CITY OF CAMBRIDGE
COMMUNITY DEVELOPMENT DEPARTMENT

To: Planning Board
From: Suzannah Bigolin, Urban Design Planner
Date: June 12, 2015
Re: **PB #175, 1-25 East Street (Phase II) Continuing Design Review**

NORTHPOINT II

GLASSWORKS AVE. ELEVATION

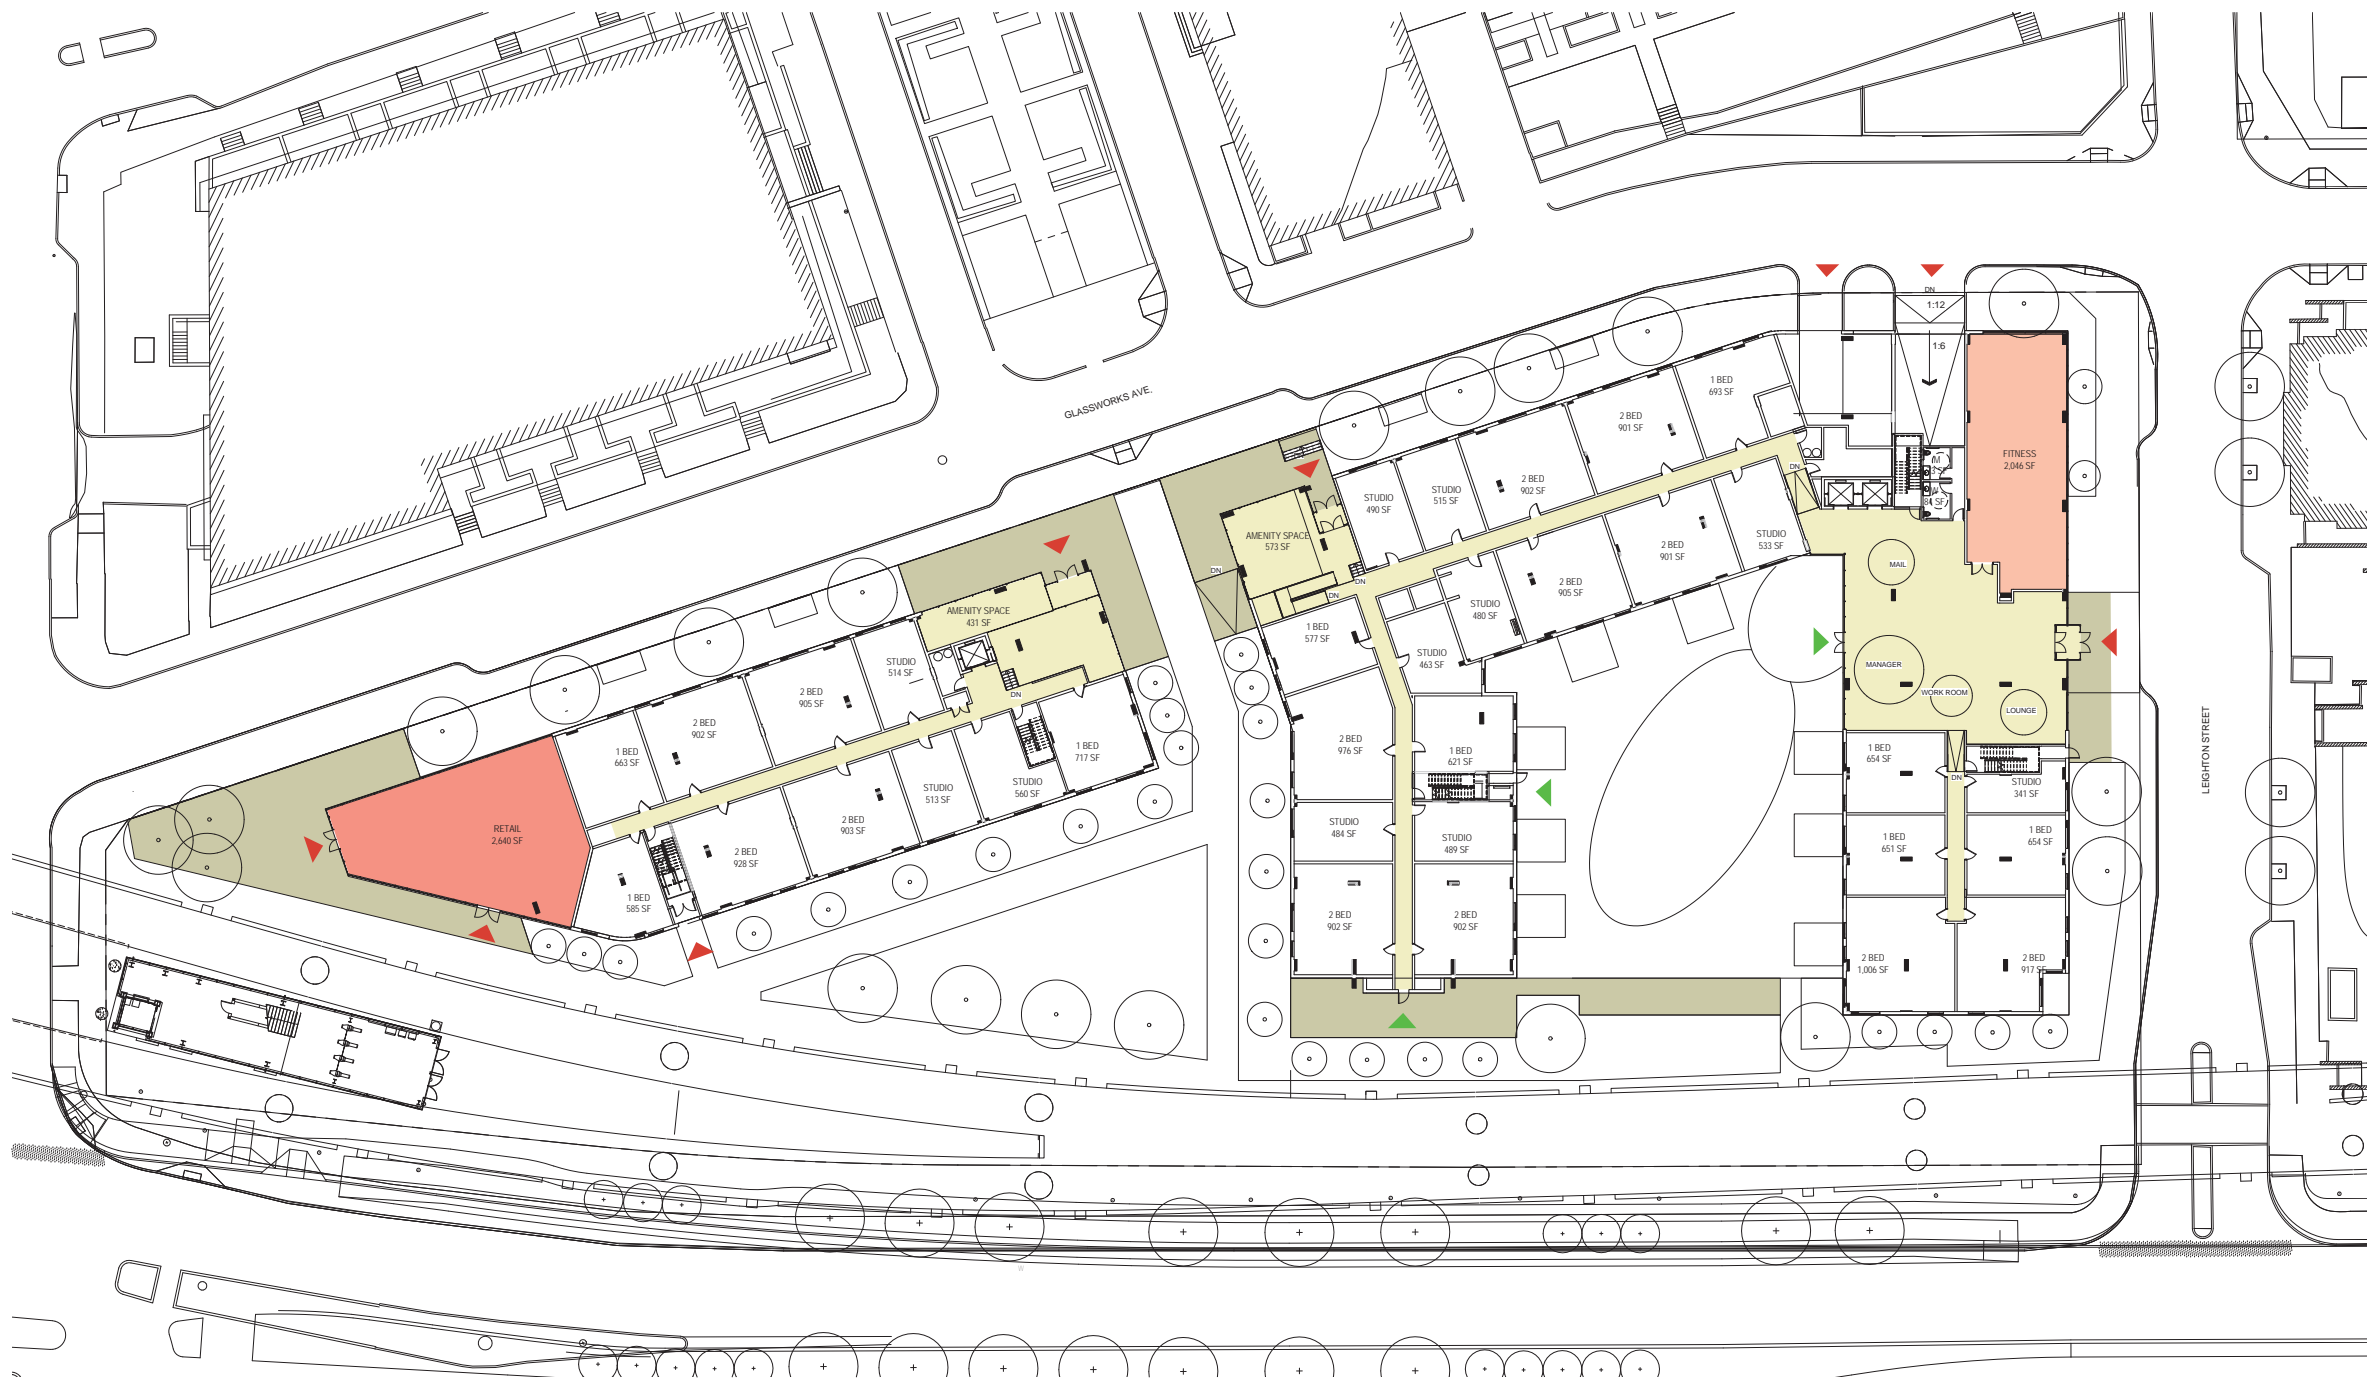
- With regard to the overall massing, changes have been introduced to create additional notches along the sixth floor, which creates new balcony space and emphasizes the corners of the two buildings on Glassworks Avenue, as well as the retail end of project. The project has also moved marginally closer to East Street and the future Lechmere station headhouse. Balconies on the south elevations are now concentrated within the courtyard, which is more of a private space and protected from the noise of the railway.

- The residential entrances and communal stoops along Glassworks Avenue are proposed to be consolidated at the building corners and moved closer to grade, which addresses accessibility concerns. Staff feel that these highly transparent corners anchor each end of the buildings, highlight nodes of activity and public presence, and celebrate the physical connection through the site. The asymmetrical configuration of the corner elements also adds interest and is successfully demonstrated in the renderings. In concentrating activity at the corners, there are sections of the street wall where windows are relatively high above the sidewalk. Staff hope to continue to work with the project team to explore opportunities to move the windows down, and creative screening and landscaping approaches to make the ground floor more welcoming.

SECTION THRU COURTYARD AND PARKING GARAGE

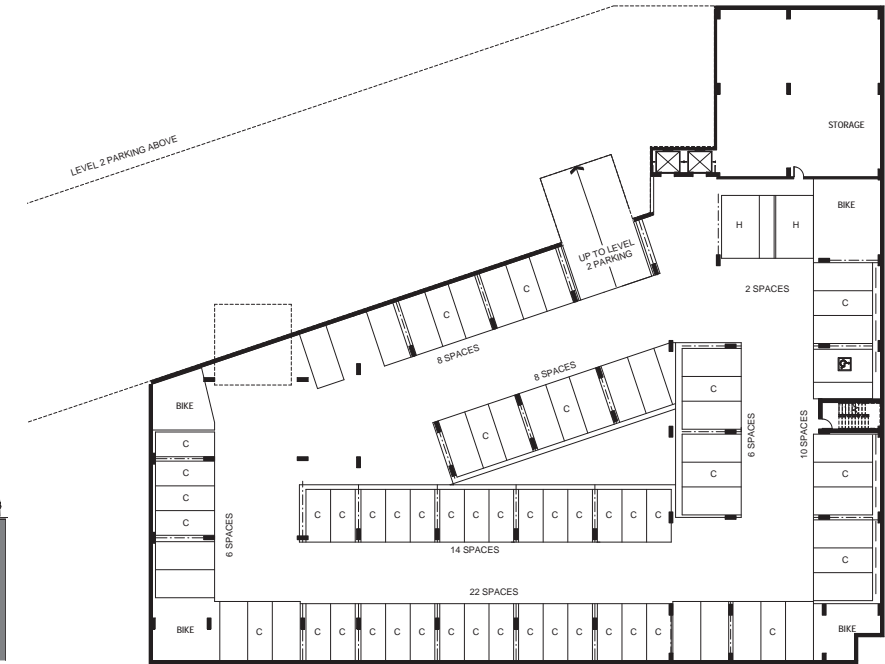
- The transition from the interior courtyard to the public realm is proposed to be a planted slope with the courtyard only 3'6" above the pathway. Specific plantings and material details are to be provided.
